# CITY PLANNING COMMISSION

- APPLICATION:
- A. Negative Declaration
  - B. Special Permit to develop a 117 unit apartment complex for senior citizens in the Limited Commercial (C-1) Zone.
  - C. Variance to reduce the required parking from 184 spaces to 90 spaces.
  - D. Lot Line Adjustment to merge two lots.

PROPOSAL: The applicant is requesting the necessary entitlements to develop a 117 unit apartment complex for senior citizens (Retirement Inns of America) on 4.04+ acres.

APPLC. NO. P87-371 MEETING DATE September 24, 1987 ITEM NO 19

SITE PLAN

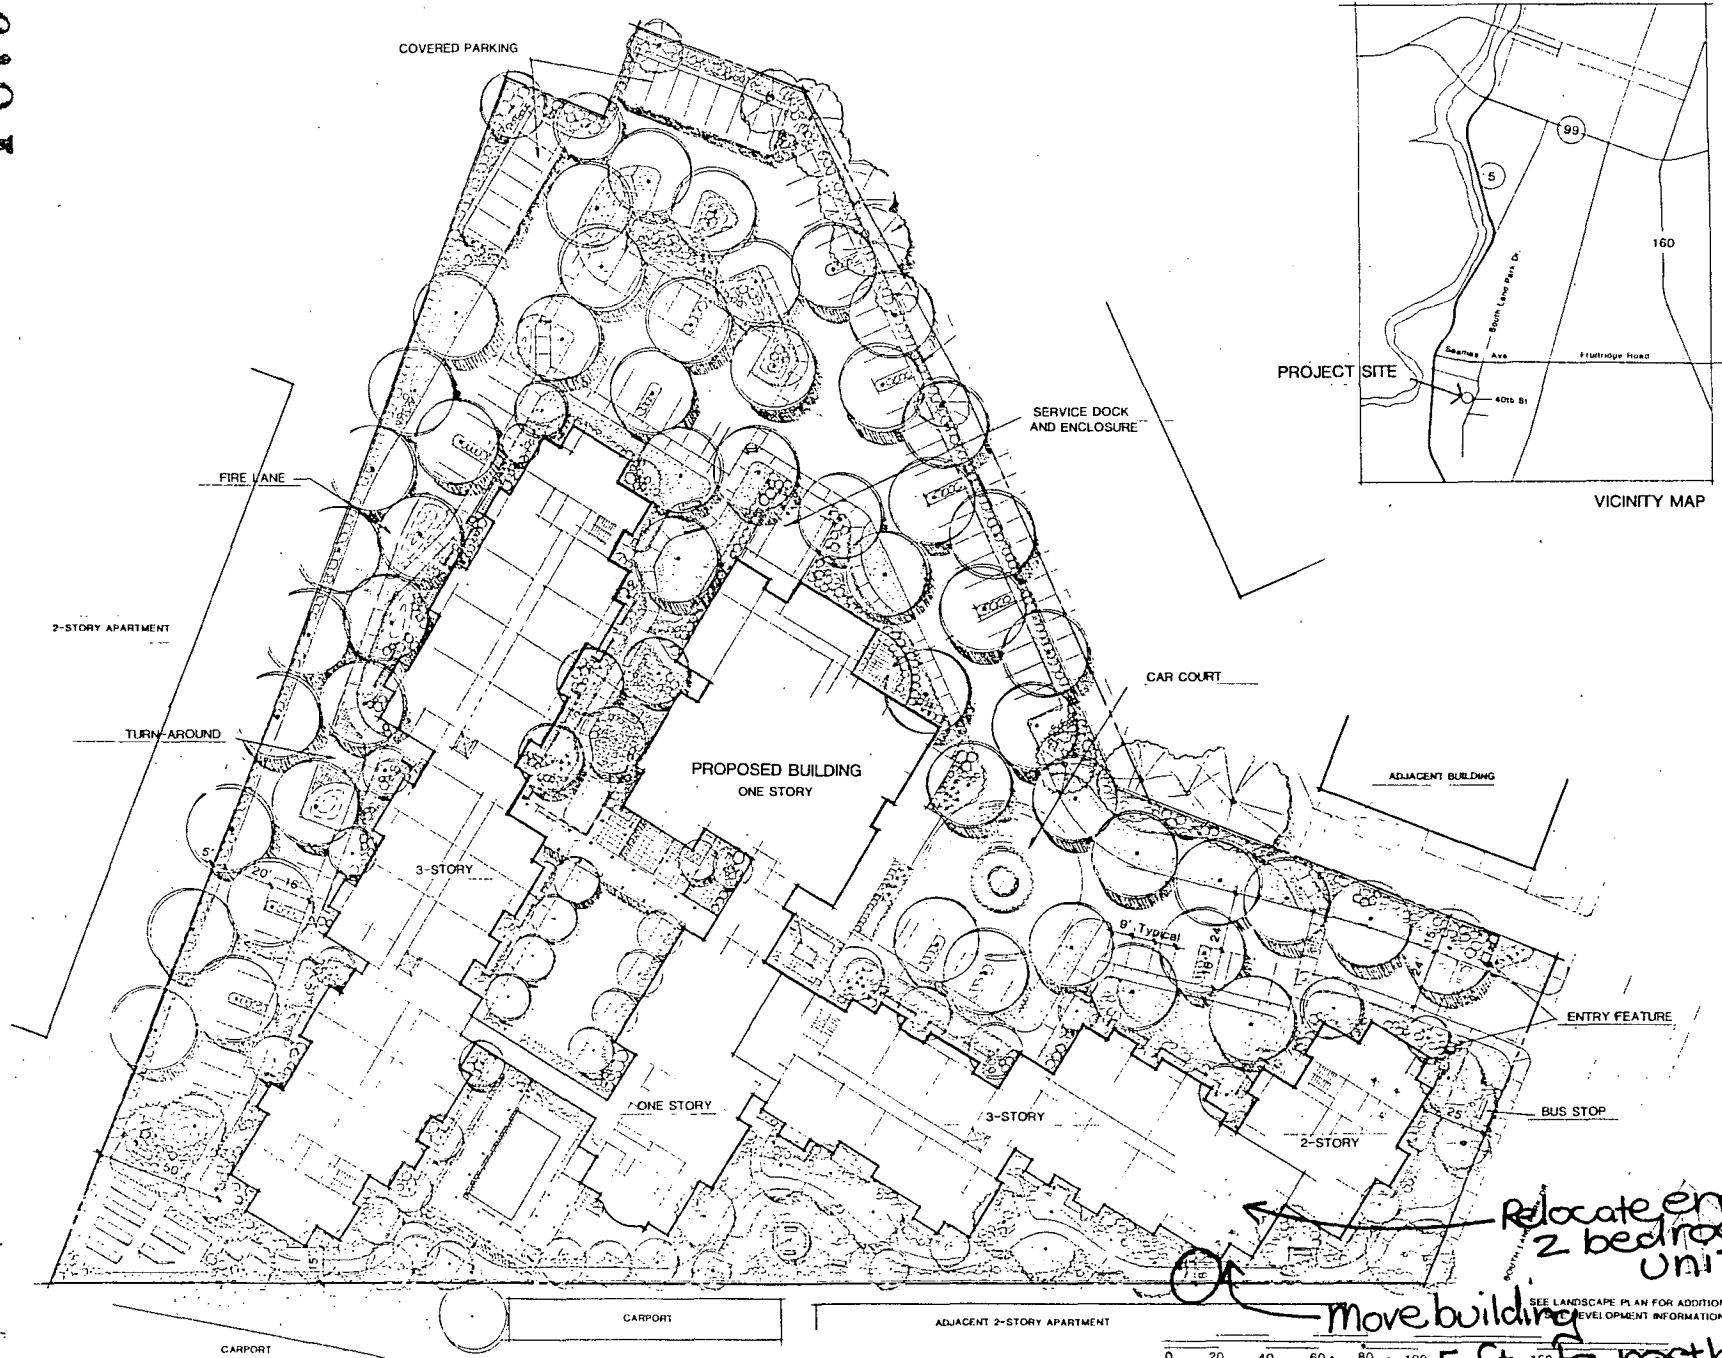
The applicant has designed the apartment complex so that the communal facilities are at the center of the project. Building heights range in size from one story to three stories with a two story structure along the South Land Park Drive frontage and one story structures in the center of the site. Overall, adequate building and landscaped setbacks have been provided; however, along a portion of the south property line an eight foot setback is proposed for one of the three story buildings. To insure greater privacy for both the residents of the existing apartment complex to the south and those of the future senior apartment complex, Planning staff recommends that this building setback be increased to 13 feet by moving the eastern three story building five feet to the north and reducing the height of the building to two stories at the end of the structure. (Exhibit C)

A six foot high screen fence is indicated along the north, south and west property lines. Staff recommends that the proposed fence be a solid barrier with the fence design and materials subject to Planning Director's review and approval. Fencing is not indicated behind the 25 foot landscaped setback along South Land Park Drive. If

Trash enclosure facilities are not indicated on the site plan as the applicant proposes to provide maid service for residents and locate the trash dumpsters in the service dock and enclosure area. This enclosure area will be required to meet Zoning Ordinance requirements for trash enclosures.

The submitted site plan indicates 13 covered parking spaces. Planning staff recommends that a minimum of 45 parking spaces be covered for the convenience of apartment residents.

The proposed circulation pattern has been reviewed by the City Fire Department. They recommended that the turn-around indicated on the site plan be able to accommodate an emergency vehicle with a 40 foot inside and 56 foot outside turning radii.

1. Revised plans indicating the relocation of one three story structure five feet to the north and the relocation of the end unit on the third story of the structure shall be submitted for Planning Director's review and approval prior to issuance of building permits. (See Exhibit C)

4. The design and materials proposed for the fences along the north, south and west property lines shall be subject to Planning Director's review and approval prior to issuance of building permits. These fences shall be solid barriers. Any fencing proposed along the South Land Park Drive frontage shall be decorative wrought iron fencing and also subject to Planning Director's review and approval.

5. A sign program for the apartment complex shall be submitted for Planning Director's review and approval prior to issuance of sign permits.
6. A minimum of 45 parking spaces shall be covered. Carport elevations shall be submitted for the review and approval of the Planning Director prior to issuance of building permits. The carport roofs shall utilize a decorative trim compatible with the main structures.

LANDSCAPE PLAN

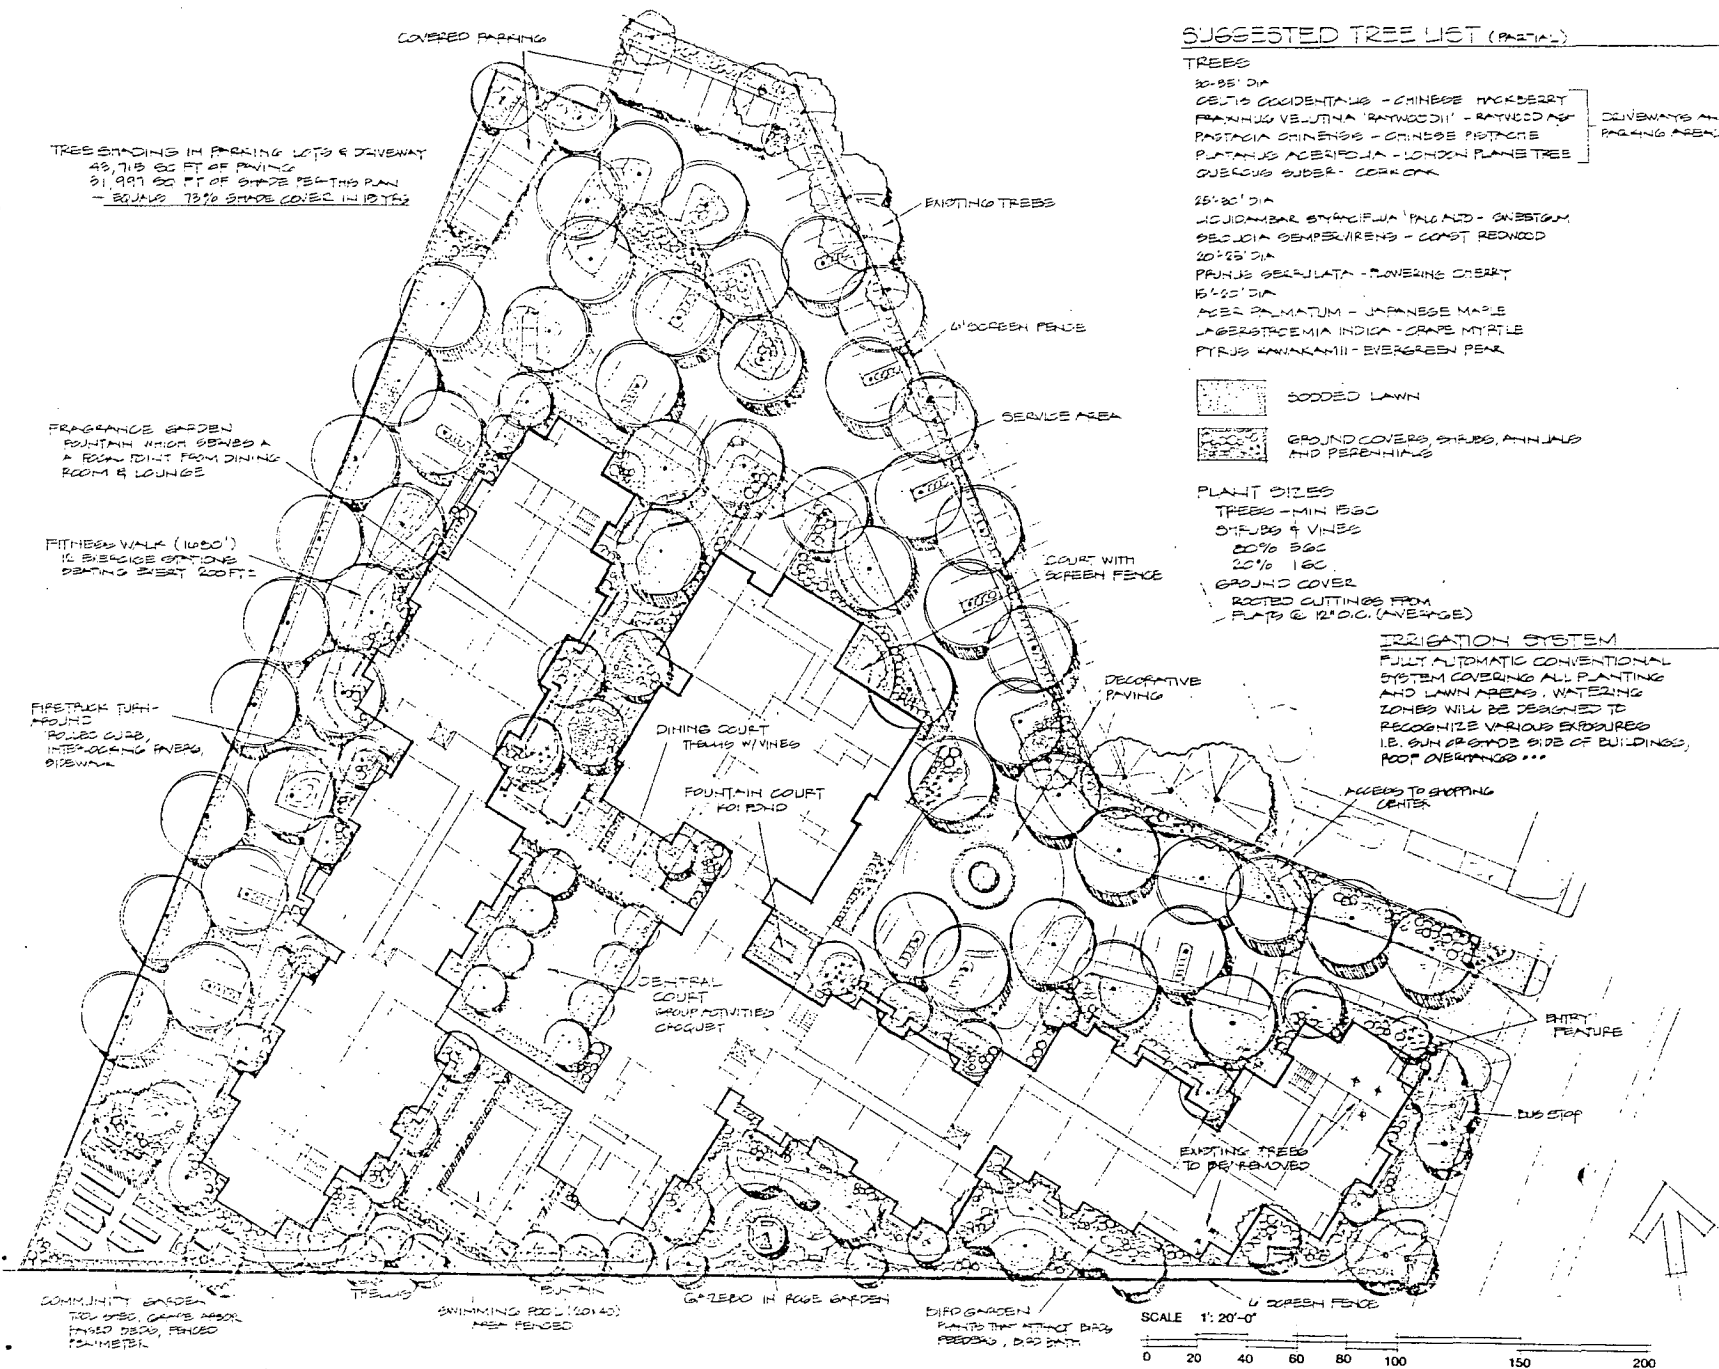
2. Revised landscape, shading and irrigation plans shall be submitted for Planning Director's review and approval prior to issuance of building permits. The applicant shall utilize evergreen trees along the north, south and west property lines, where possible, for screening purposes, excluding the area south and west of the community garden.
